GENERAL APPLICATION

Location Address: 2135 LINCOLN STREET

Explanation of Request: SUBMITTAL SITE PLAN APPROVAL - 16 UNIT APARTMENT BUILDING FINAL TAC

SUBJECT: Site Plan review for a 16 unit residential development.

P.E.#: 76036
DATE: 7/1/20
SCALE: 1"=10'
SHEET NO.: C1
1 OF 9
PROJECT NO.: 20-34

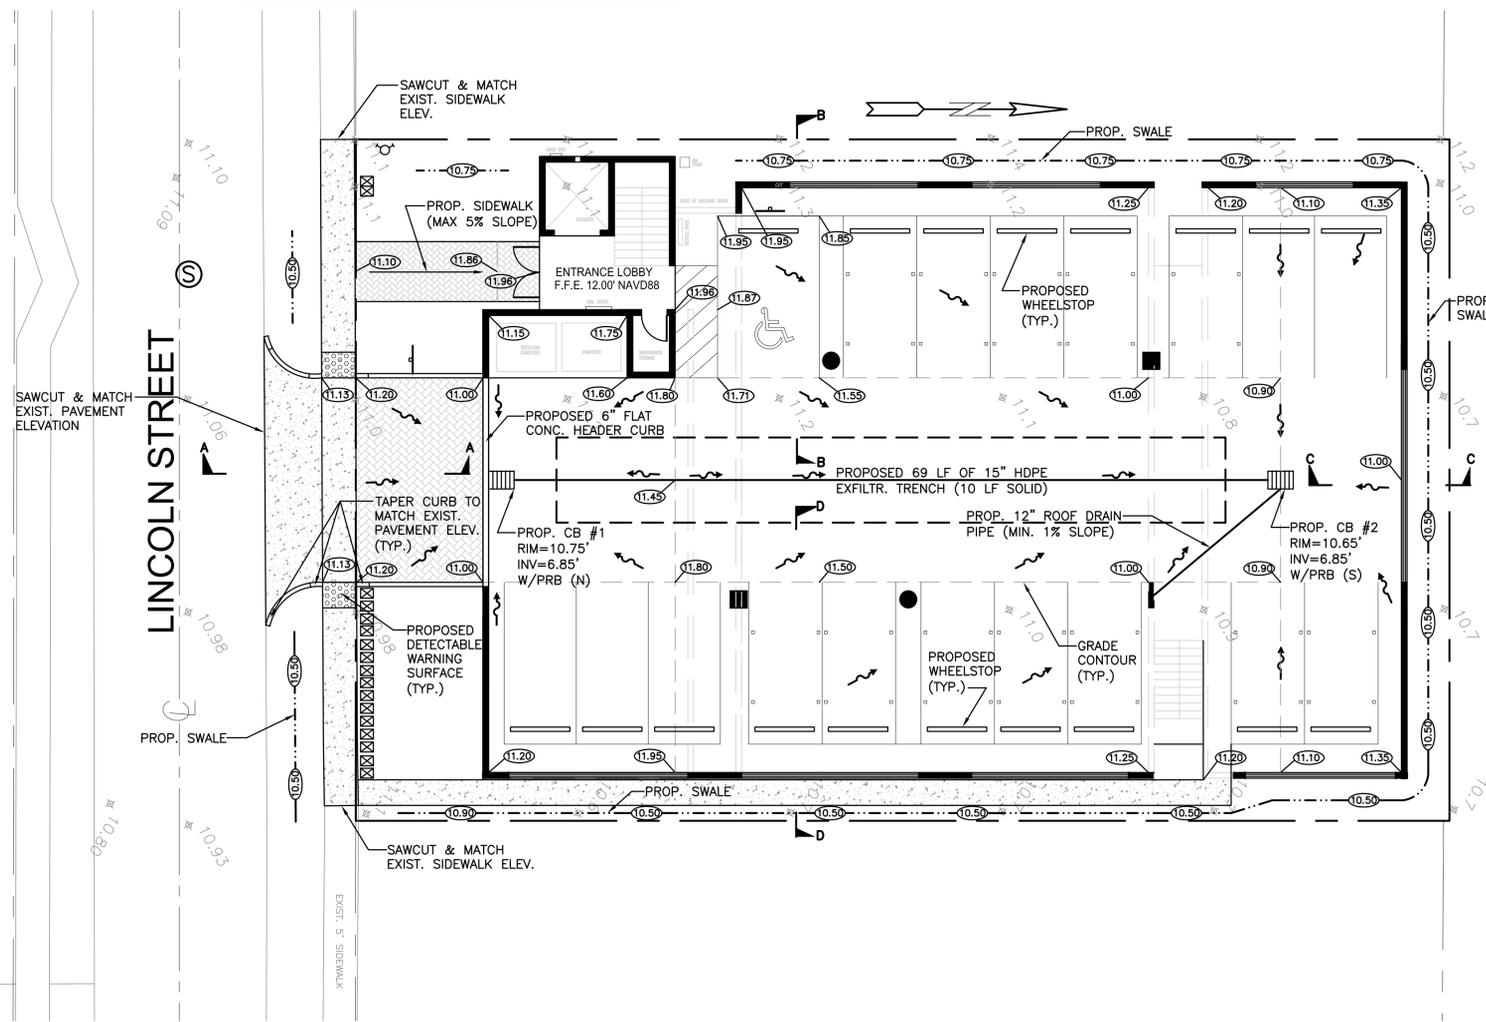
1. This property is within Flood Zone X. Per City Ordinance Chapter 154.50, for new multifamily residential, the FFE should be a minimum of 18-inches above the highest point of the crown of the adjacent road = $11.10' \text{ NAVD } 88 + 1.5' = 12.6' \text{ NAVD } 88$.
2. Provide FFE for all proposed enclosed areas on the ground floor.
RESPONSE: Please see attached civil engineering plans. Please note that the first floor consists of entrance and parking. The minimum finished floor elevation is the 2nd floor of the proposed structure.
3. Submit civil plans for grading, drainage and pavement.
RESPONSE: Please see attached civil engineering plans.
4. Submit drainage calculations.
RESPONSE: Please see attached drainage calculations.
5. Indicate how roof drainage will be collected and retained.

6. Show perimeter cross sections including swale transition areas meeting adjacent property elevations. All stormwater must be retained onsite.
RESPONSE: Please see cross-sections on sheet C-2.

RESPONSE: Please see sheet C-2 for roof drain connection.

P.E.#: 76036
 DATE: 7/1/20
 SCALE: N.T.S.
 SHEET NO.: **C3**
 3 OF 9
 PROJECT NO.: 20-34

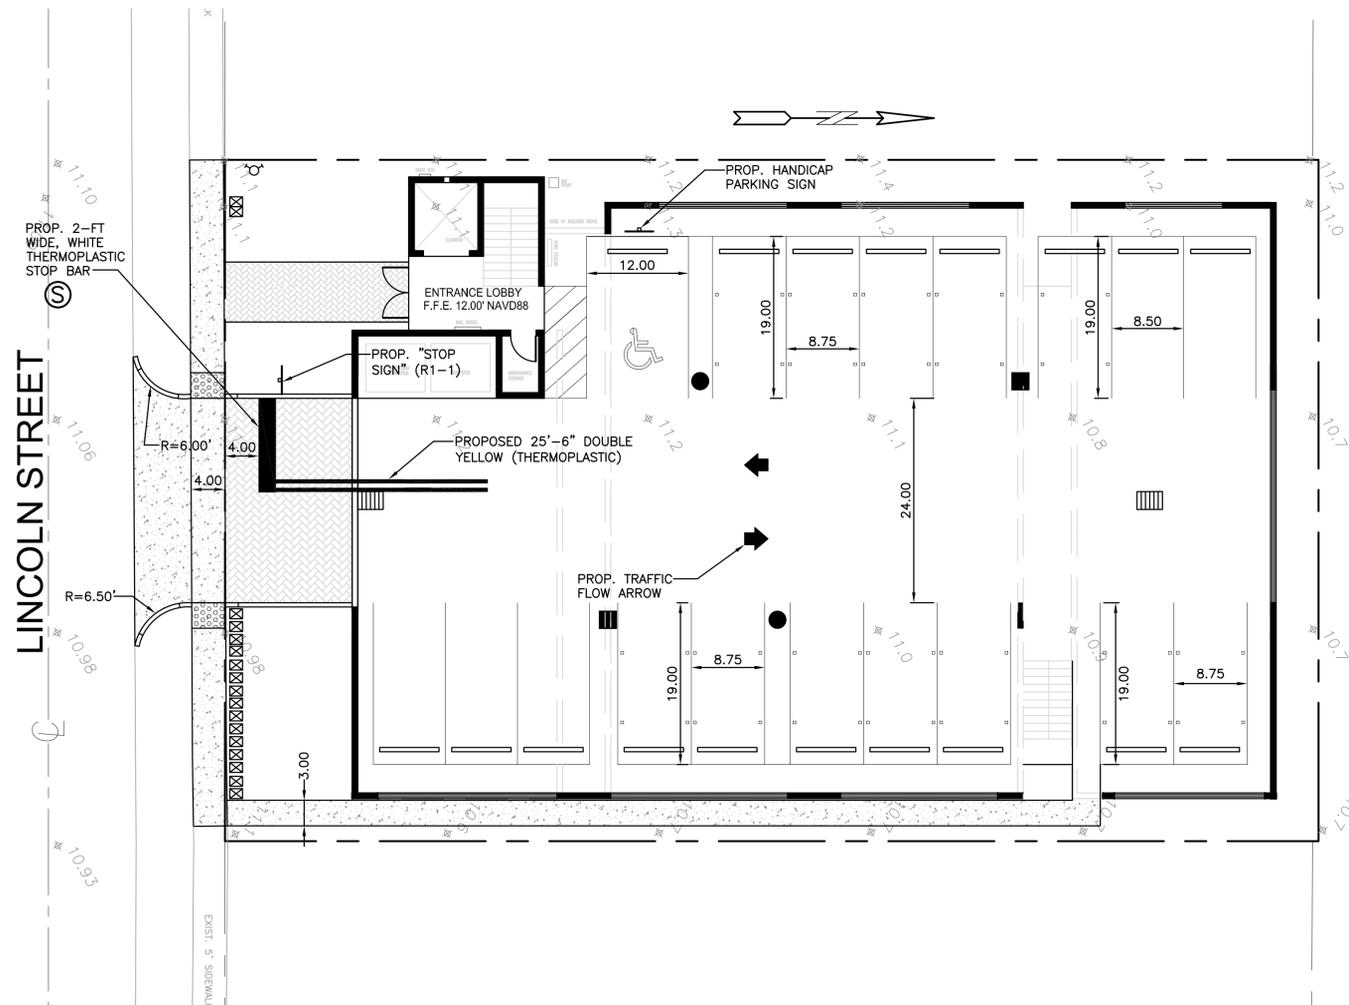
RESPONSE: Please see attached civil engineering plans.
9. Provide curb ramp with detectable warnings at all accessible crossing. Provide detail for detectable warnings.

RESPONSE: Please see plan sheet C-3.
10. Certified MOT plans required at the time of City Building Permit review.
RESPONSE: Acknowledged.
11. Park impact fees requirements will be required to be satisfied at the time of City building permit.

P.E.#: 76036
 DATE: 7/1/20
 SCALE: 1"=10'
 SHEET NO.: C4
 4 OF 9
 PROJECT NO.: 20-34

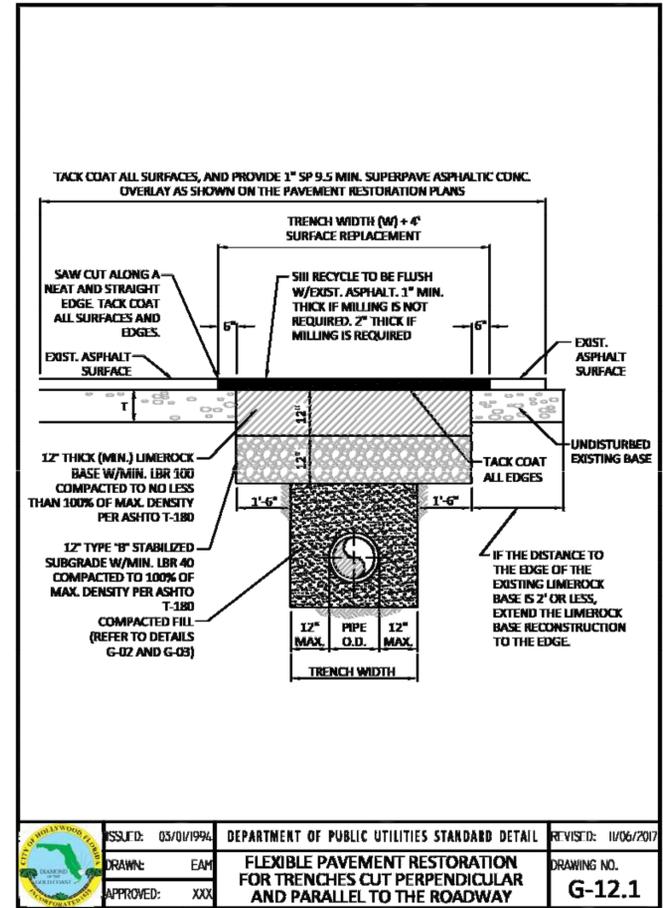
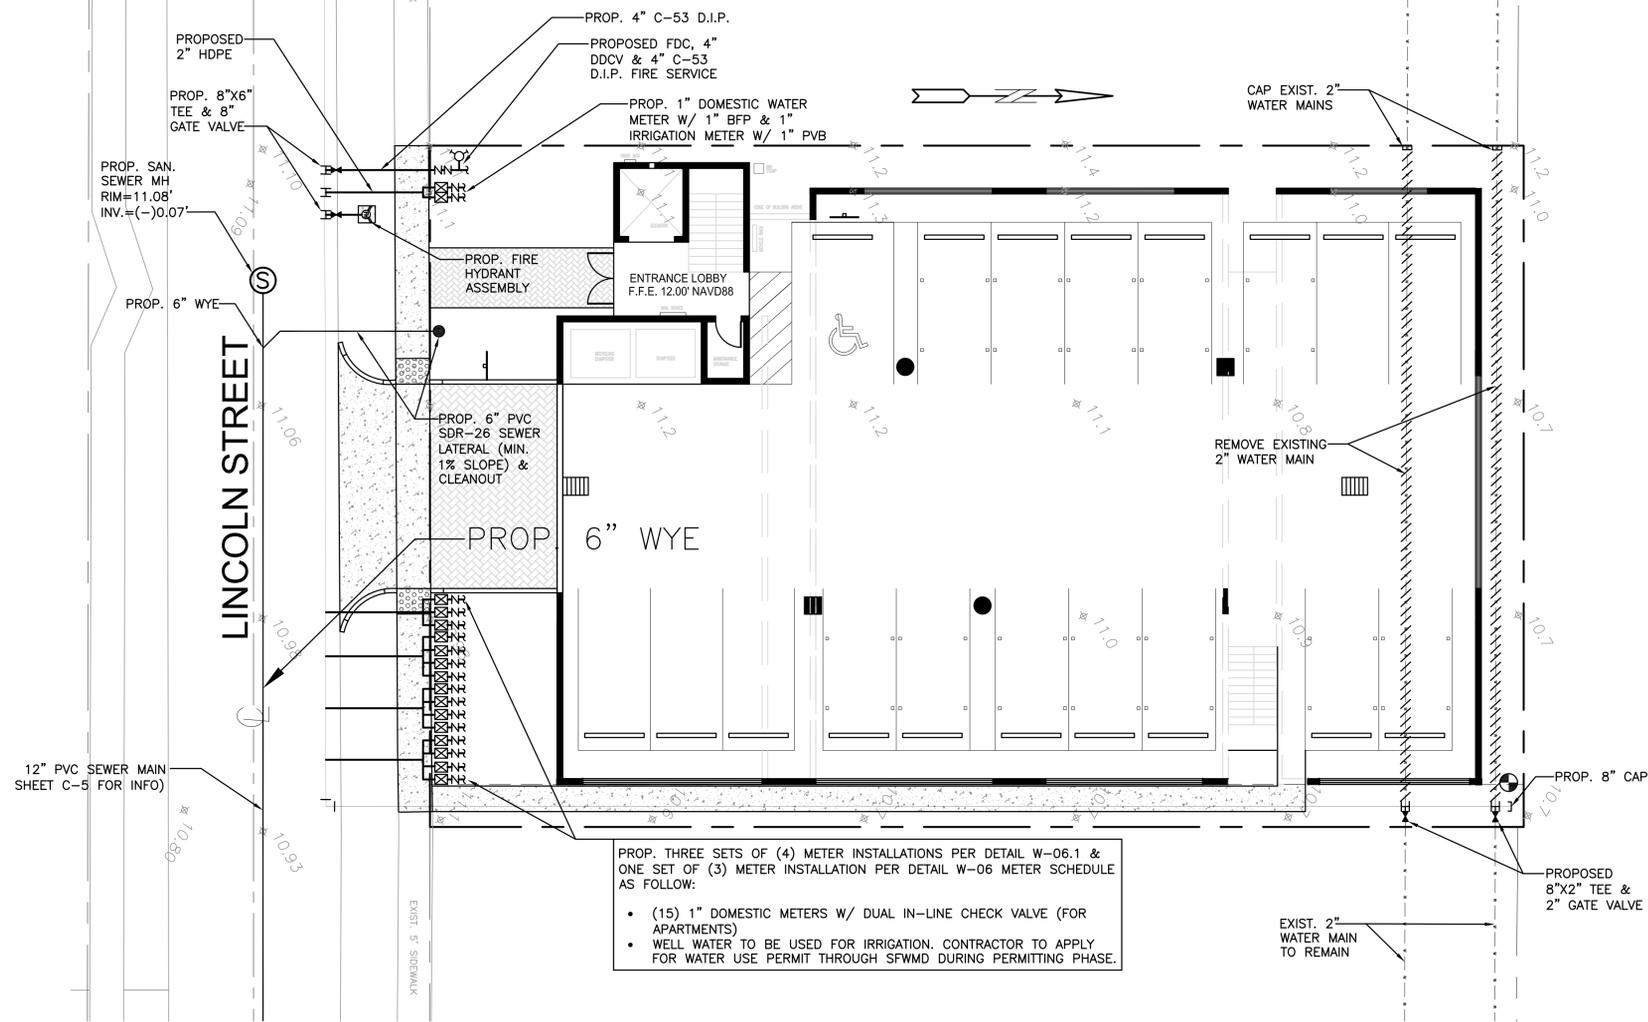
RESPONSE: Please see attached civil engineering plans.
5. For the parking garage, indicate items such as but not limited to **all parking and drive aisle dimensions**, ramp slope, vehicle turning radii, **traffic control markings and signage for vehicular traffic circulation and flow**, ADA accessibility, and location of building structural columns.

RESPONSE: Please see civil engineering plan sheet C-4 and architectural plans.
6. On Site Plan and on floor plans, fully dimension (depth and width) all parking stalls. Indicate width of all spaces adjacent to any obstruction, i.e. stairwells, columns, etc. **Parking stalls with obstruction on one side shall be minimum 9.5' wide and 10.5' wide with obstruction on both sides.**

P.E.#:76036
 DATE: 7/1/20
 SCALE: 1"=10'
 SHEET NO.: C7
 7 OF 9
 PROJECT NO.: 20-34

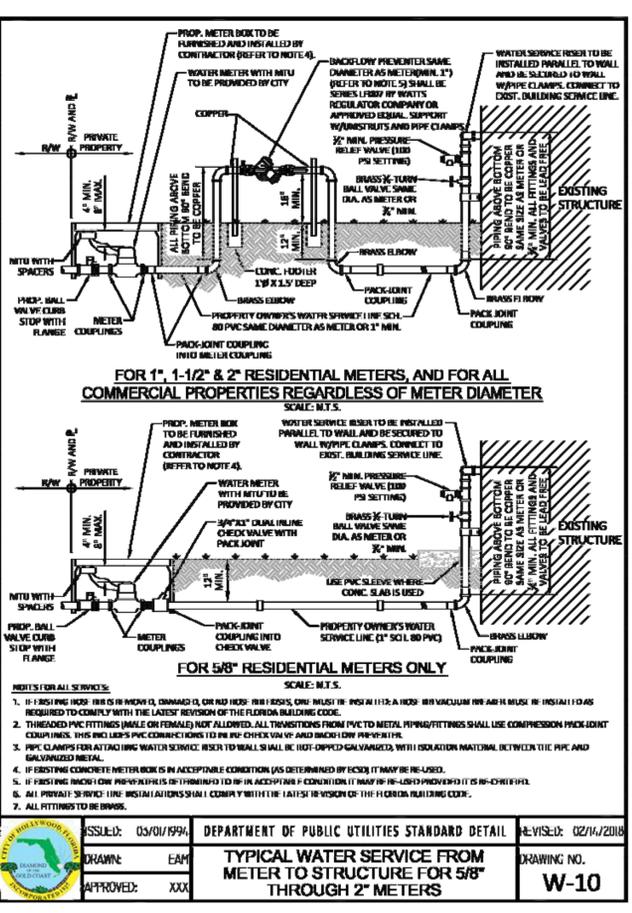
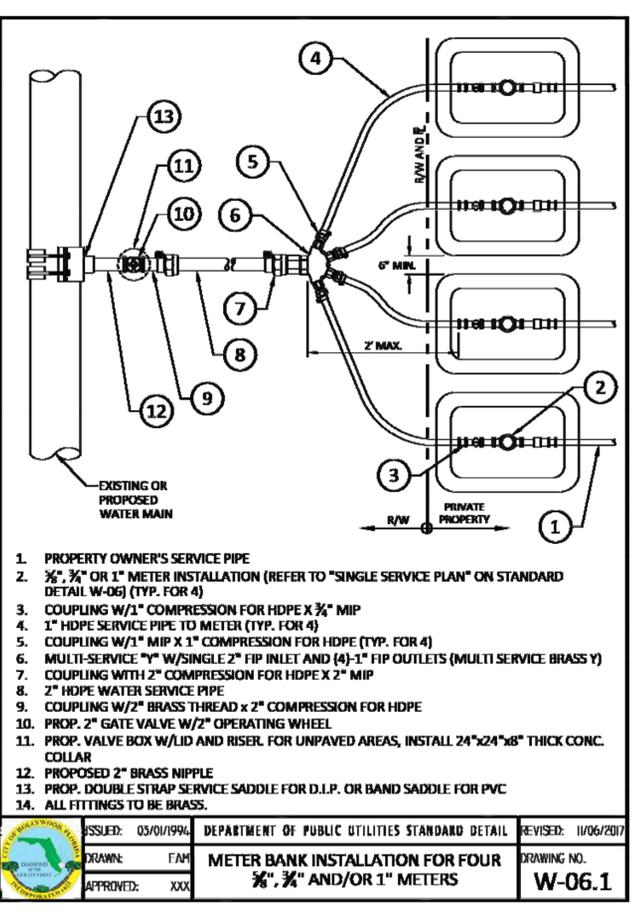
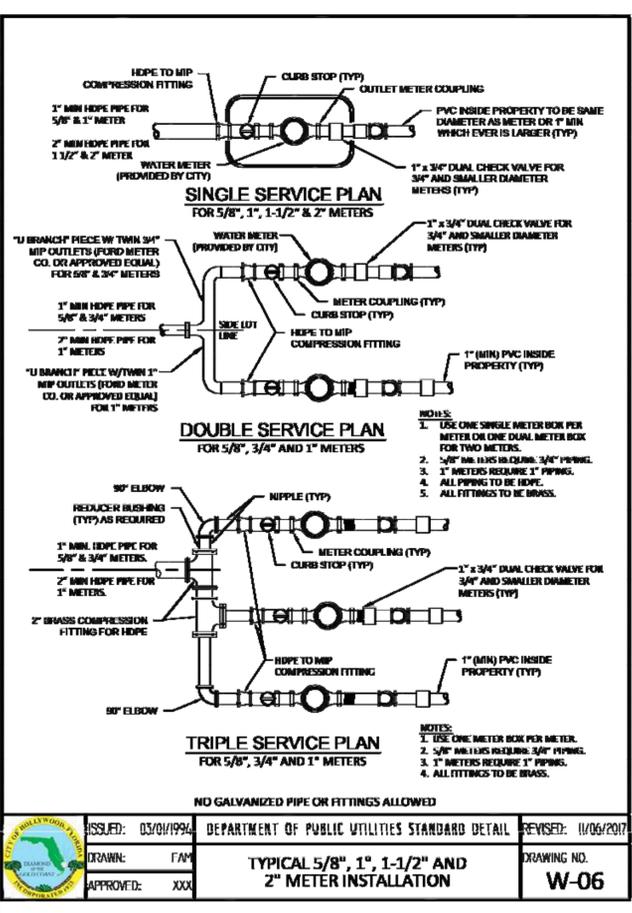
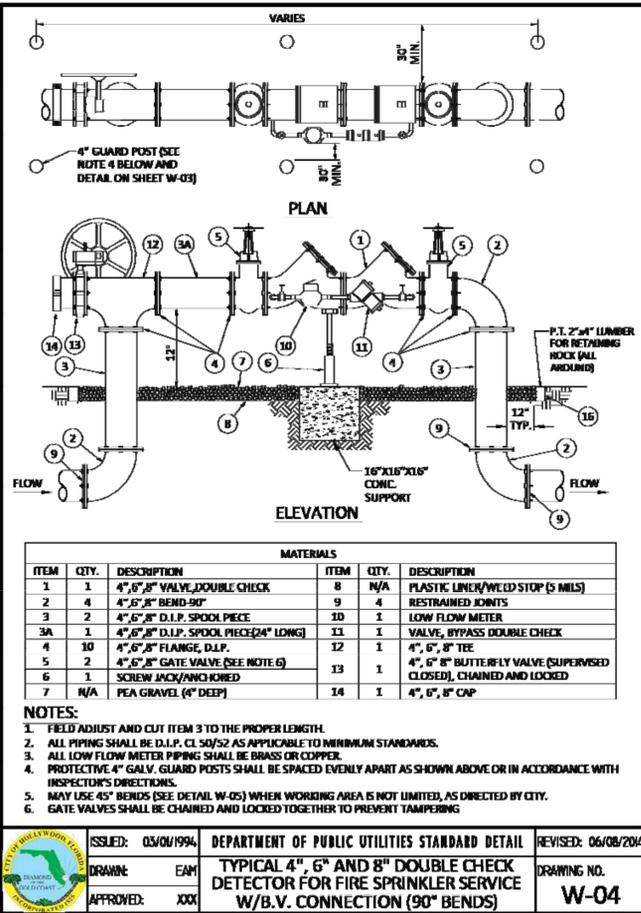
RESPONSE :Please see water and sewer extension plan sheet C-5 and onsite water and sewer plan sheet C-7.
9. Submit utility plans indicating location and sizes of existing City water lines, proposed water connections, water meter, backflow preventer, service lines, sewer cleanout, sewer lateral, or septic system, etc.

RESPONSE: Please see attached civil engineering plans.
3. Provide a note on civil drawing all underground fire main work must be completed by fire protection contractor holding a Class I, II, or V license per FS 633.102.

RESPONSE: Please see sheets C-5 and C-7.
10. Provide Water & Sewer demand calculations.
RESPONSE: Please see sheet C-7.
11. Update plans to Include the City's latest standard water and sewer details. These can be obtained from Mike Zaske at 954-921-3930 or mzaske@hollywoodfl.org

RESPONSE: Please see sheet C-7.
4. A Knox box will be required at the main entrance. Please show on the next submittal.
RESPONSE: Please architectural plans.
